Mr. A. M. Toye,
Bridge Engineer.
Materials & Research Division,
(Foundation Section)

August 29, 1962.

Re: Payne River Bridge - United Counties of
Stormont, Dundas & Glengarry.

REPORT OF SOIL INVESTIGATION
SITE OF PROPOSED NEW BRIDGE
OVER PAYNE RIVER
COUNTY ROAD NO. 12
FINCH TOWNSHIP
FOR
UNITED COUNTIES OF STORMONT, DUNDAS & GLENGARRY

TEST HOLE NO. 3

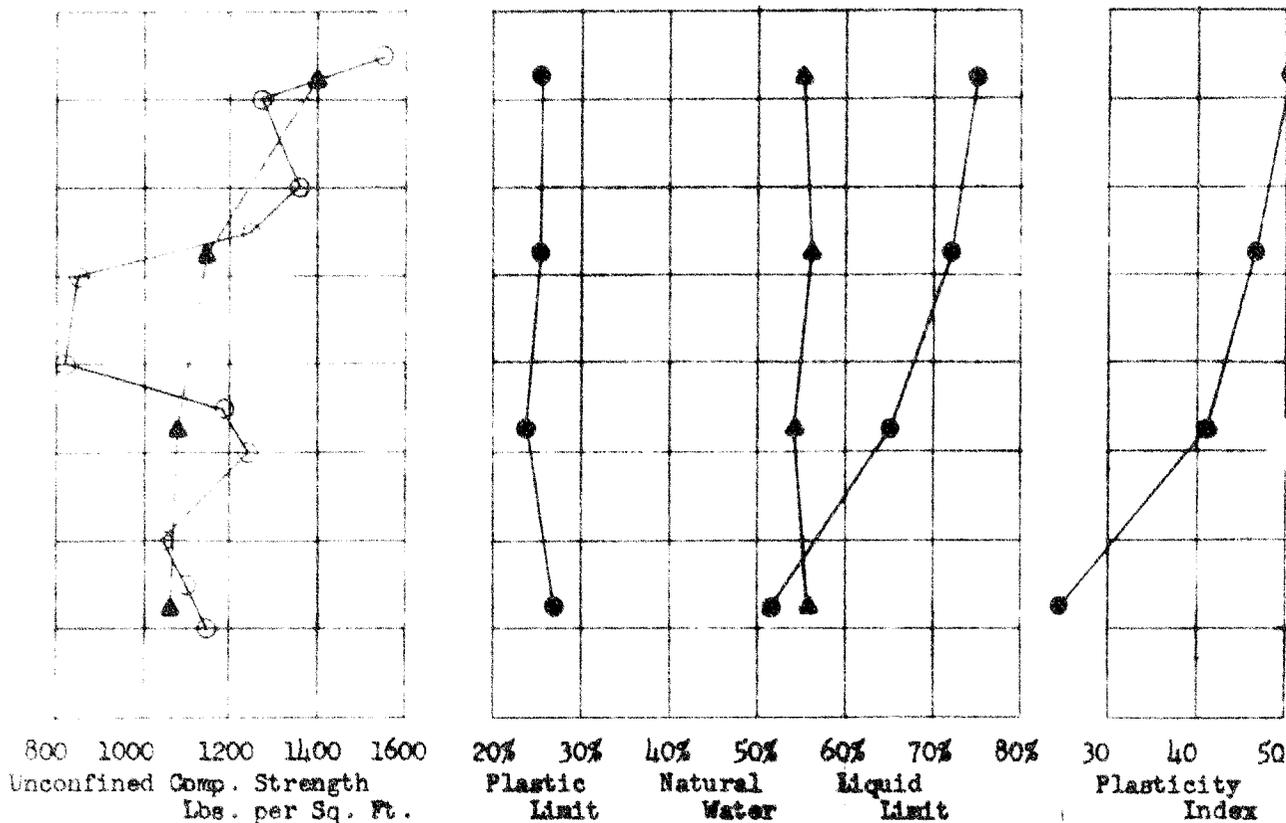
From these results we have arrived at an average shear strength for the clay layer of 550 pounds per square foot. We have not included the result from TW 20 because it is obviously from the dried crust.

SITE PLAN AND PROFILE

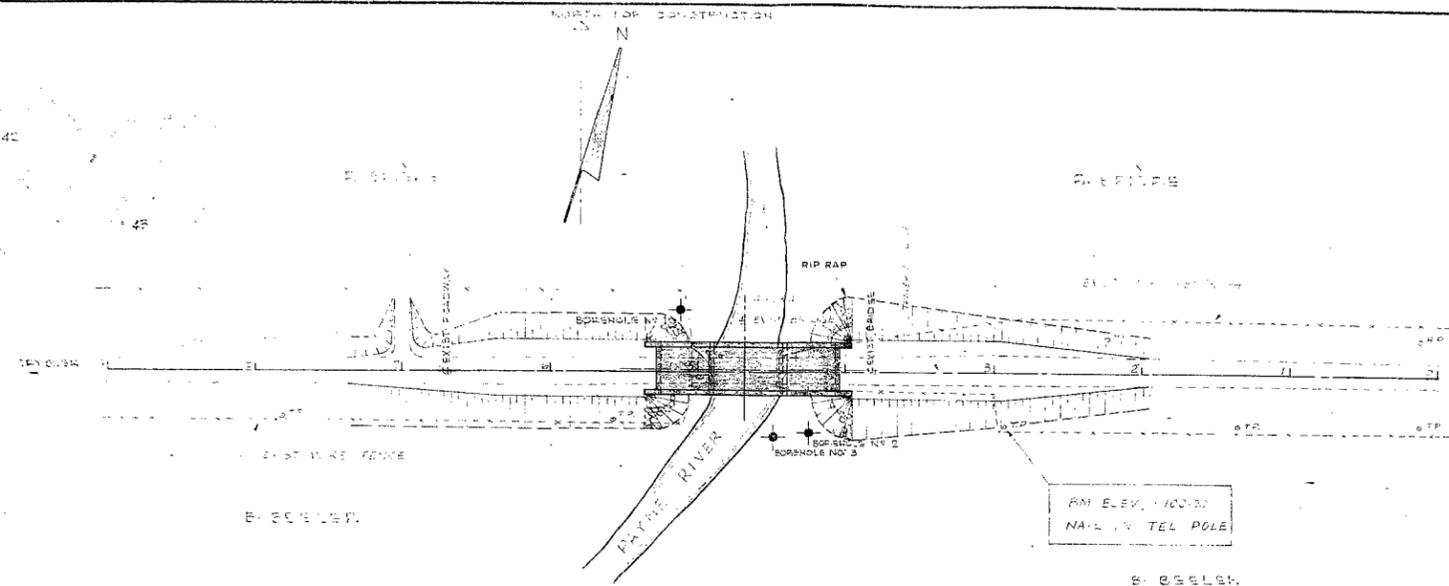
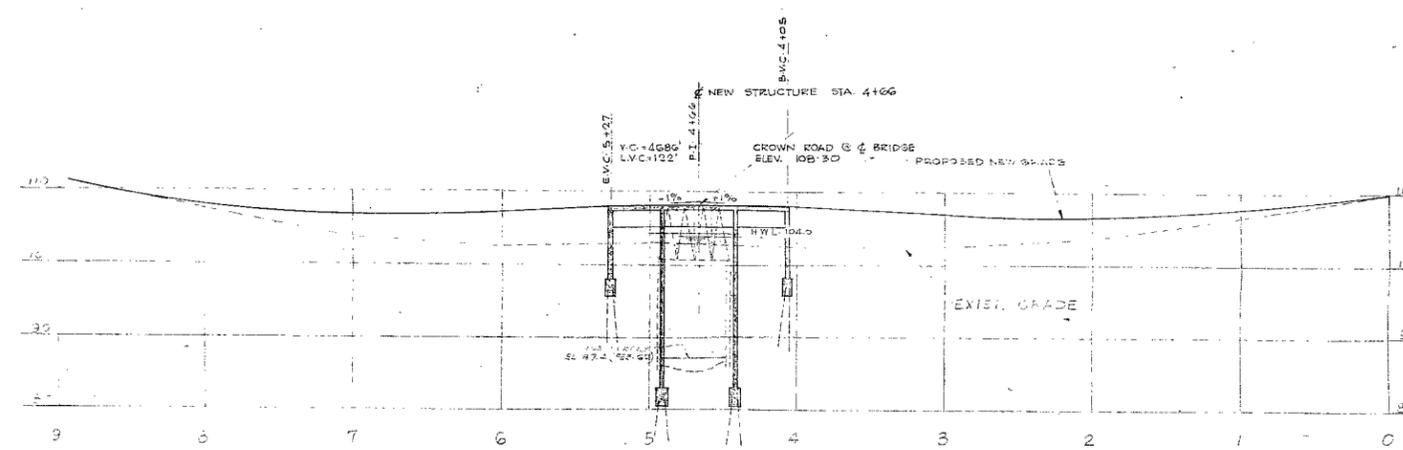
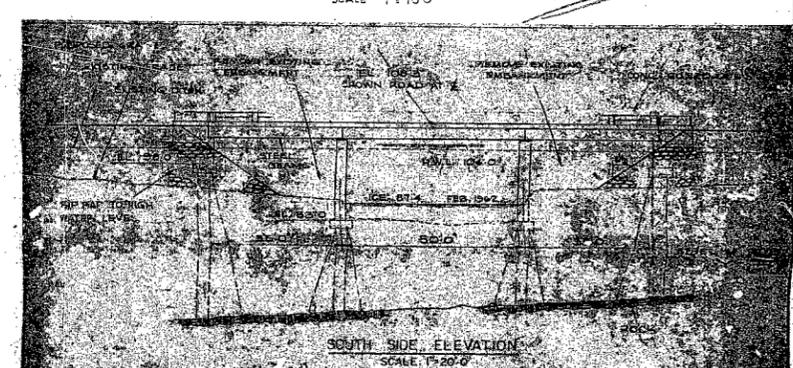
After looking over our preliminary site plan and profiles and reviewing our soil report (No. S 252-62) we are concerned with the stability of the river banks when an additional four feet of fill is placed for the new grade. In our original stability analysis we stated that the safe maximum height was considered to be 18 feet. However, now that we have your profiles and have plotted the soil profile on them, we find that low shear strength of the soil occurs to a depth of approximately 30 feet below the existing grade, when an additional four feet of fill is placed the figure becomes 34 feet.

While the proposed new grade at Elevation 108 indicates a total thickness of 34 feet of critical soil we now think that you should consider an open abutment type of bridge with an embankment slopes not exceeding 2 horizontal to 1 vertical. The underlying clay is sensitive and construction operations during the placing of the new approach fills may result in slip failure in the clay at the river banks.

It is our understanding that during the spring runoff the South Nation river backs up into the Payne river and, therefore, there should not be any great problem of erosion of the banks at this bridge site. Side slopes of the approach embankments can be safely held to 2 horizontal to 1 vertical, as shown on your site plan.
